Leighton Consulting, Inc.

Project No. 603314-007

**Subject: Initial Response to California Geologic Survey Review Comments
Fault Rupture Hazard Review
Beverly Hills High School
241 South Moreno Drive
Beverly Hills, California
CGS Application No. 03-CGS0960**

Figure 1

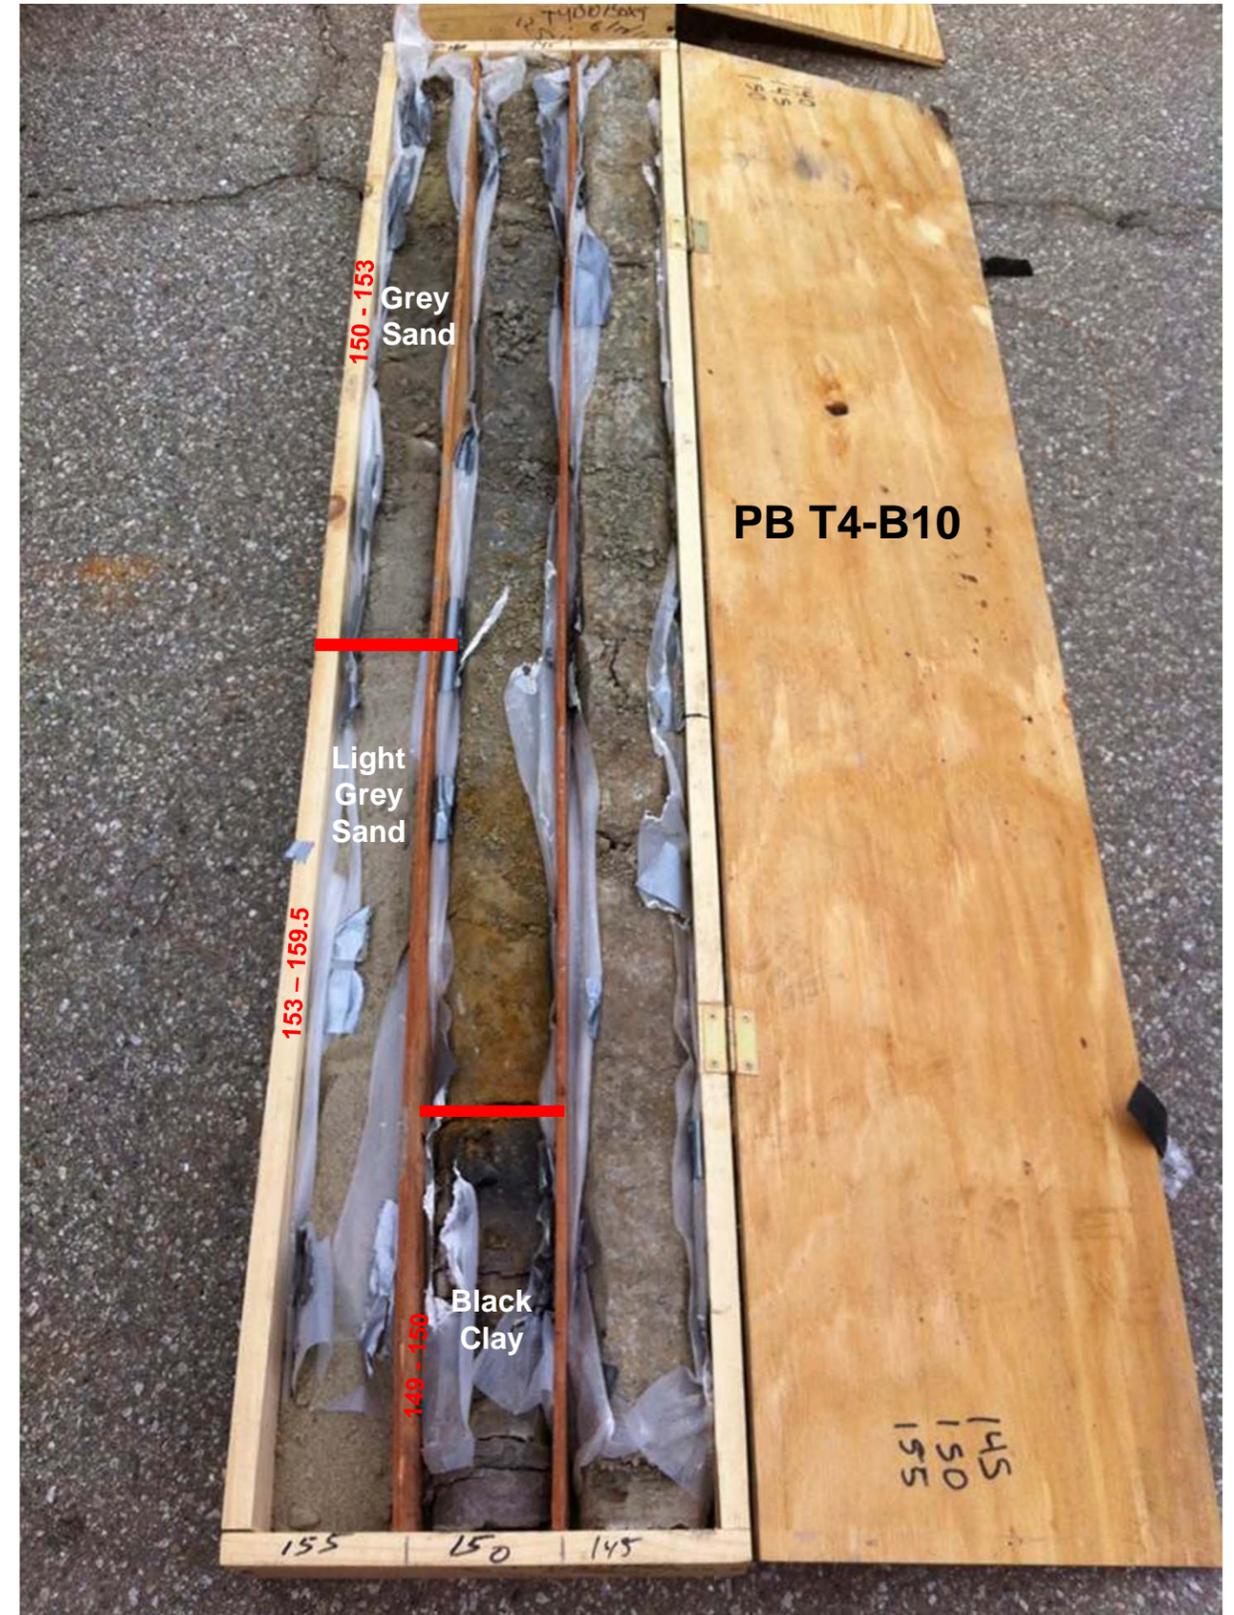
The reviewers also question whether the soil fractures observed in Trench FT-2 (and FT-3) may be fault controlled and question whether the soil microfabric analysis conducted is conclusive. While we did not sample every fracture, the ones that we did sample were the most major, and did show layers that were offset. They also extended from the top to bottom of the trench. We did not sample those that died out vertically up or down. Figure 1 shows photographs taken during sample collection at Station 1+46.5 (north wall) and at station on 1+50 on the south wall. Obvious offset gravel layers are shown in the photographs.

The reviewers suggest that lateral slip may have occurred across these fractures. Lateral slip should have resulted in shearing of the clays in the fractures, while pure extension might not have. Again, significant shearing was not observed in the microfabric analysis. Instead the clays were observed to be translocated (not sheared) and the secondary fabric was estimated to be tens of thousands to hundreds of thousands of years old. Even if the fractures were a result of fault movement (instead of slope movement during seismic shaking as we believe), the fractures have been demonstrated to be pre-Holocene in age and are thus not active.

Figure 2

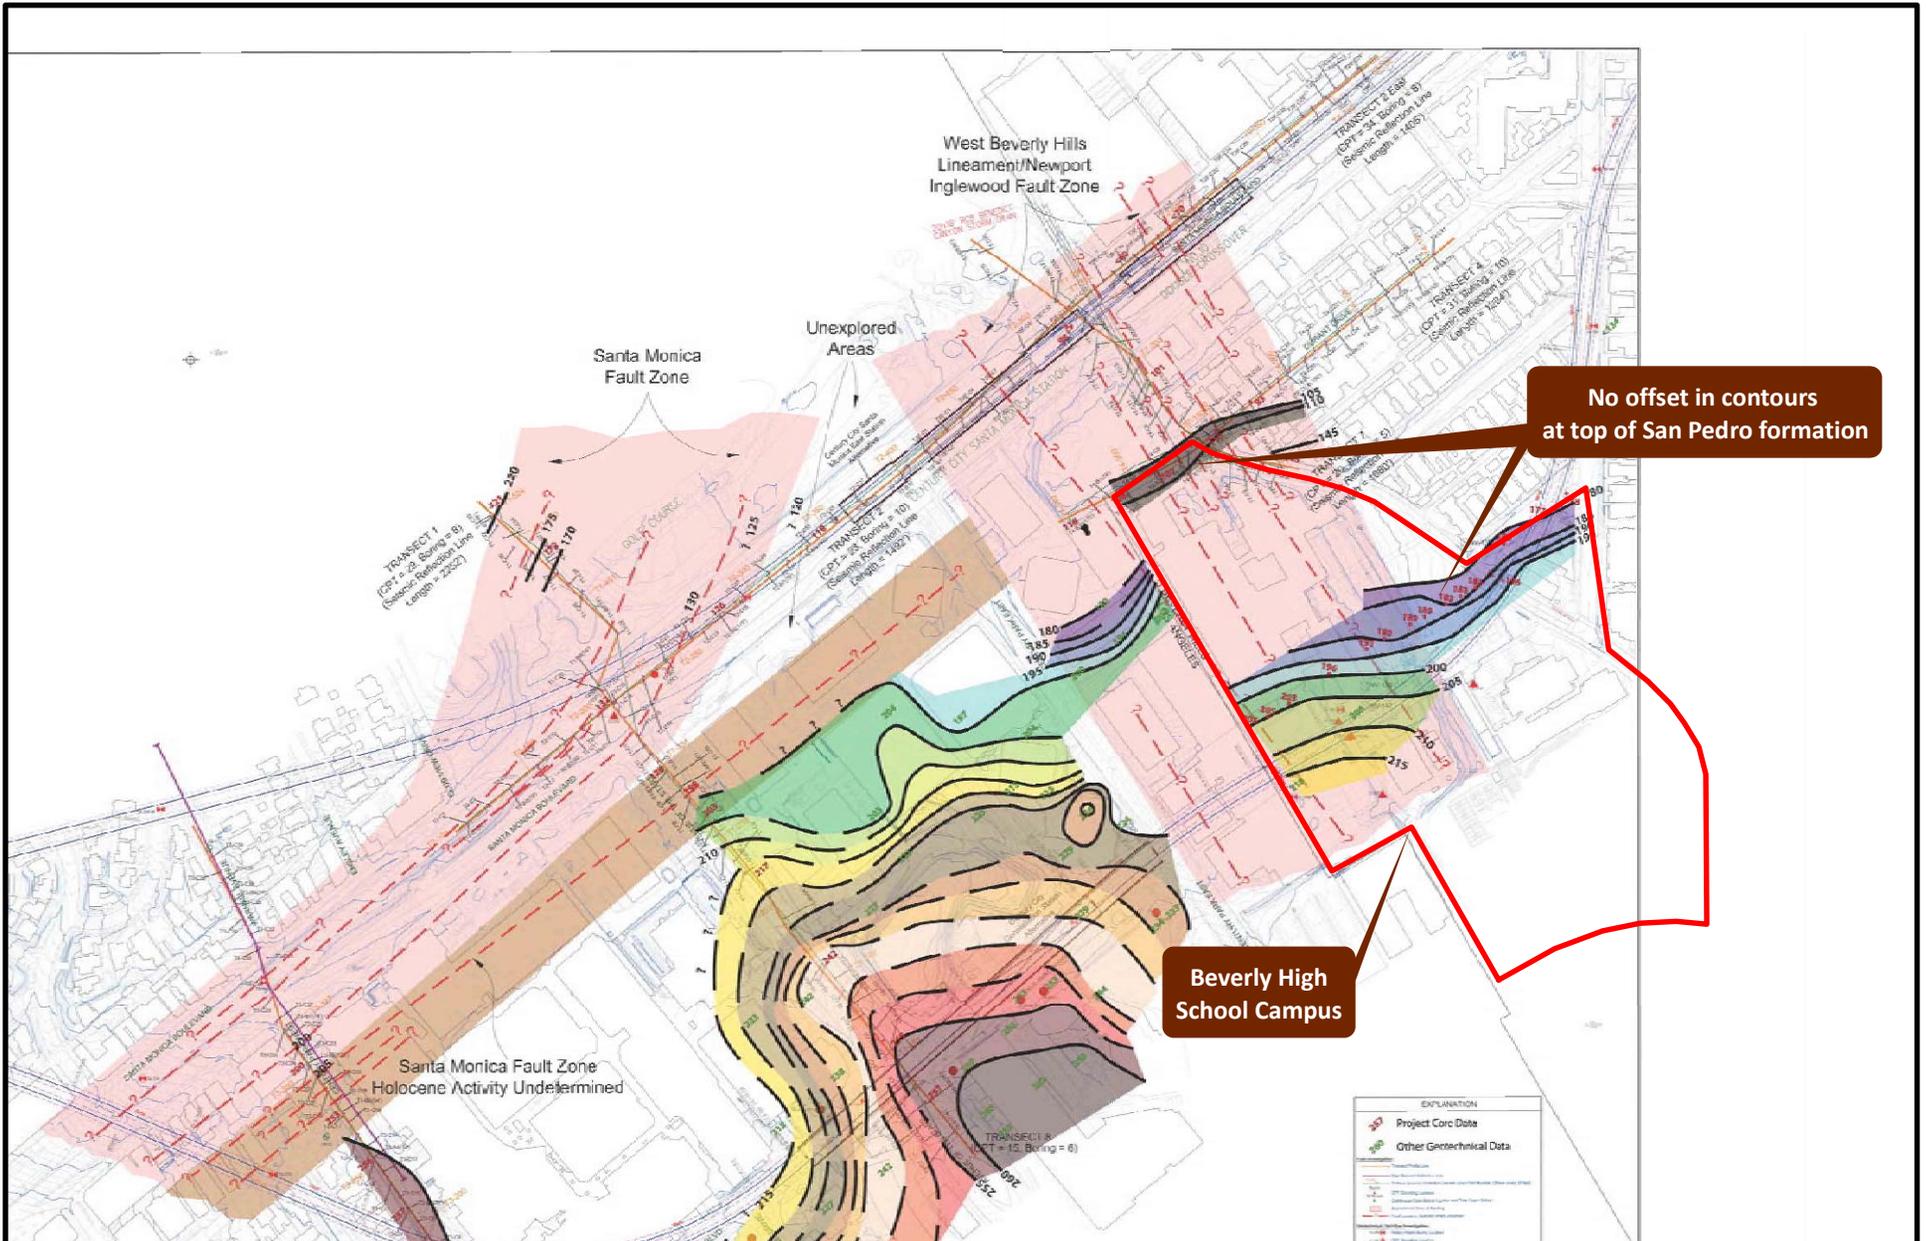
During the field visits with the reviewers to observe the core samples, there was much discussion regarding the difficulty in recognizing pure strike slip faulting within the cores if the units were near horizontal. In the review sheet, the reviewers ask us to demonstrate an unbroken horizontal stratigraphic sequence below fractures and tilted ped surfaces in Trench FT-2. But the units are not horizontal neither in the trench nor in the subsurface. They dip to the east and (as the reviewers point out) there is a significant elevation difference to the north. There is about 100 feet of elevation difference between the bedrock contact in our Boring CB-1 on Transect A and PB's Boring T4-B10 on Transect B (a horizontal distance of about 720 feet).

Our trenches cross many of PB's (2011b) mapped faults. However, the reviewers note that our trenching may not be adequate because this "assumes the trend of the suggested faults is well understood." We did not make this assumption; PB makes the statement that: "Clear evidence for a wide zone of faulting is observed along the WBHL. Multiple lines of evidence from three different east-west transects show faulting, forming a zone on the order of 550 feet." They have defined the zone and indicated the evidence of faulting was "clear." But apparently it was not very "clear" as we could not reproduce their findings independently and upon review of our data (they have collected no new data), PB has changed their fault interpretations (PB, 2012). In particular, they now infer a fault with significant offset extending from just west of BHHS (west of our CB-1 along Transect A) northward between our Boring CB-13 and PB's T4-B10 (along Transect B). They suggested up to 350 feet of right lateral offset along this fault. They make this interpretation based on offset elevation contours along the top of the San Pedro Formation. With about 100 feet of elevation difference between Transect A and B, 350 feet of right lateral offset should also show significant apparent vertical offset across this fault (perhaps 40 to 50 feet or more) between CB-13 and T4-B10. However, there is only about 6 feet of elevation difference between the bedrock contact in PB's Boring T4-B10 and our Boring CB-13 (on the other side of PB's inferred fault, see photo Figure 2). There is no evidence for a significant fault between these borings.
